Normative Annex 200A Proposal

Updates to Clause 1

Updates to Clause 200

Replace subclause 200.4.2 with the following:

Figure 200-2 – Super-PON PMD test points

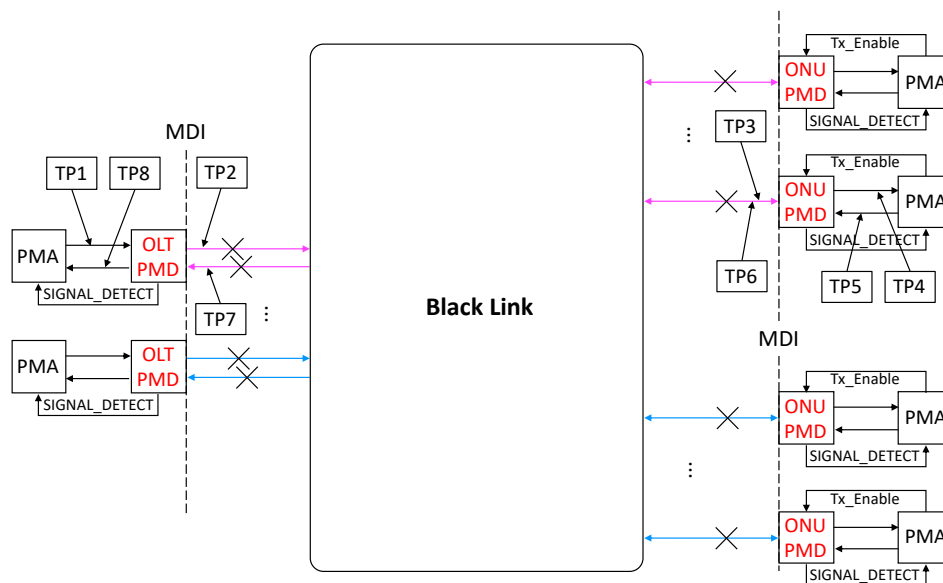
The PMD sublayer is defined at the reference points shown in Figure 200–2 for Super-PON type PMDs, using the ‘black link’ approach.

Test points TP1, TP2, TP3, and TP4 refer to the downstream channel, while test points TP5, TP6, TP7, and TP8 refer to the upstream channel. In the downstream channel, TP2 and TP3 are compliance points, while in the upstream channel TP6 and TP7 are compliance points. TP1, TP4, TP5, and TP8 are reference points for use by implementers. The optical transmit signal is defined at the output end of a patch cord (TP2 for the downstream channel and TP6 for the upstream channel), between 2 m and 5 m in length, of a fiber type consistent with the link type connected to the transmitter. Unless specified otherwise, all transmitter measurements and tests defined in 200.9 are made at TP2 or TP6. The optical receive signal is defined at the output of the fiber optic cabling (TP3 for the downstream channel and TP7 for the upstream channel) connected to the receiver. Unless specified otherwise, all receiver measurements and tests defined in 200.9 are made at TP3 or TP7.

The electrical specifications of the PMD service interface (TP1 and TP4 for the downstream channel and TP5 and TP8 for the upstream channel) are not system compliance points (these are not readily testable in a system implementation).
